# UNITED STATES PATENT AND TRADEMARK OFFICE

10/523,584

<b>Office Action Summary</b>	Application No. 10/523,584	Applicant(s) DUPONT ET AL.	
	Examiner Vinh T. Luong	Art Unit 3682

# **ATTACHMENT**

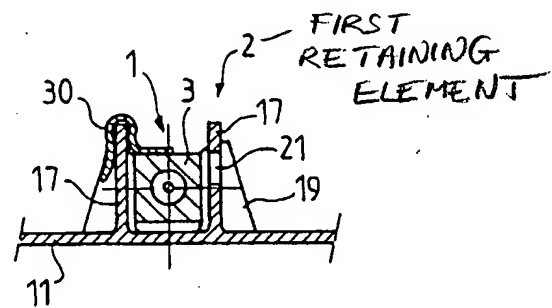
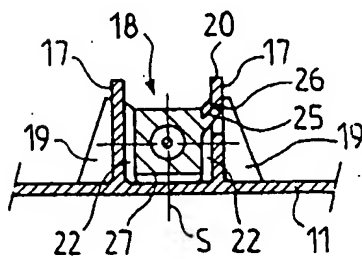
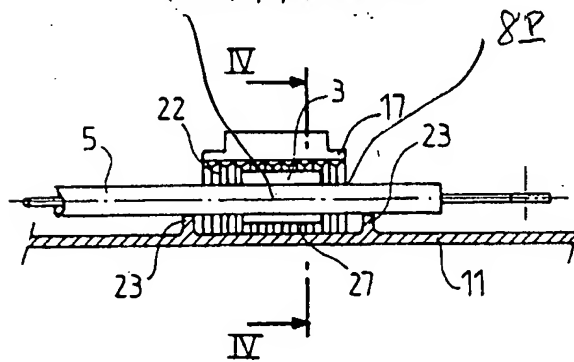
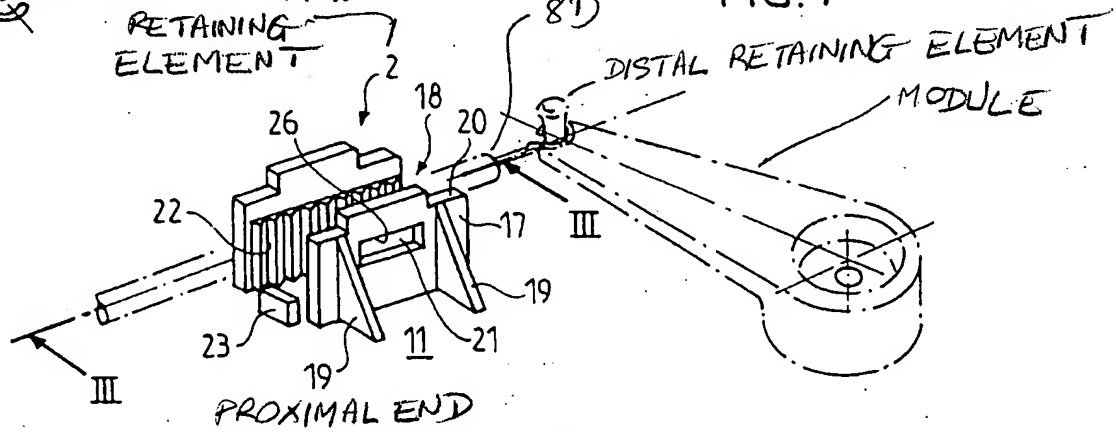
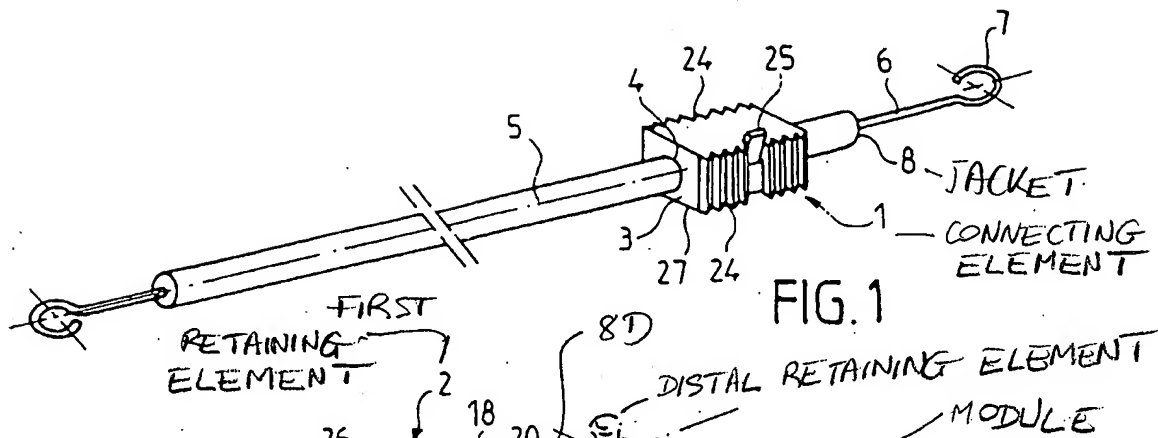
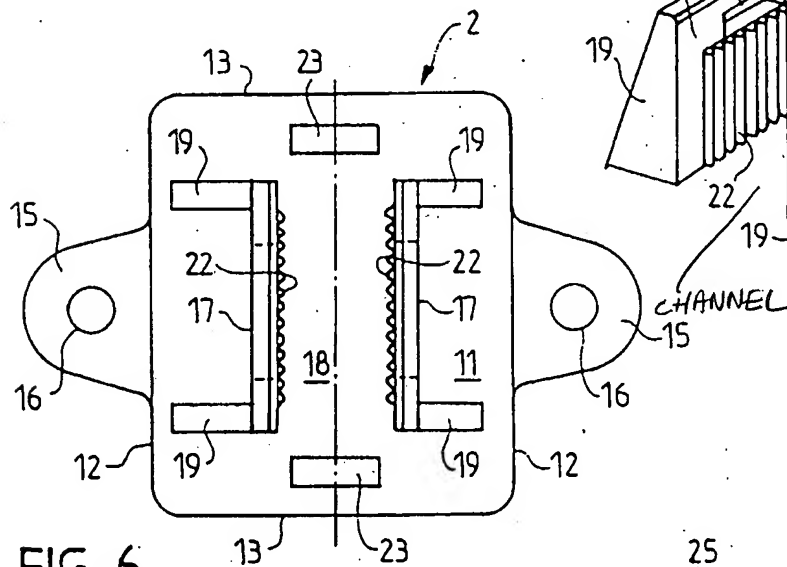
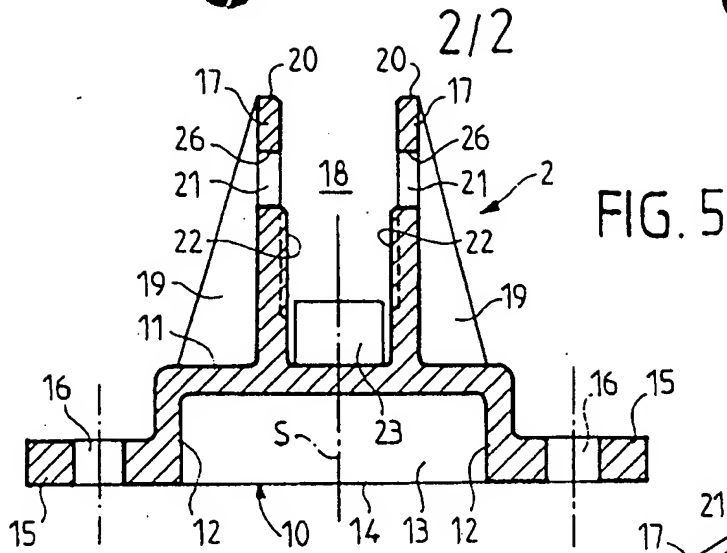
Regarding claim 1, Michel teaches a control device for a module (unnumbered, shown by dashed line in Fig. 2. See Attachment hereinafter "Att.") forming a lock mechanism, of the type comprising a Bowden-type cable containing a cable 6 having two ends, a proximal end (Att.) and a distal end respectively, the cable 6 being housed in a jacket 8 having two ends, a proximal end (8P in Att.) and a distal end (8D in Att.) respectively, which are immobilized by two proximal 1 (Fig. 1) and distal (see Fig. 2 in Att.) retaining elements, characterized in that at least a first end (8P in Att.) of the jacket 8 is connected to a corresponding first retaining element 2 (Figs. 5 and 7) by means of a connecting element 1 attached to the first end of the jacket 8.

Regarding claim 10, the first end of the jacket 8 is its proximal end (8P in Att.).

Regarding claim 11, the proximal end (8P in Att.) of the cable 6 is provided with a block 7 (Fig. 8) for securing this cable 6, the shell 12 forming a housing for this securing block 7.
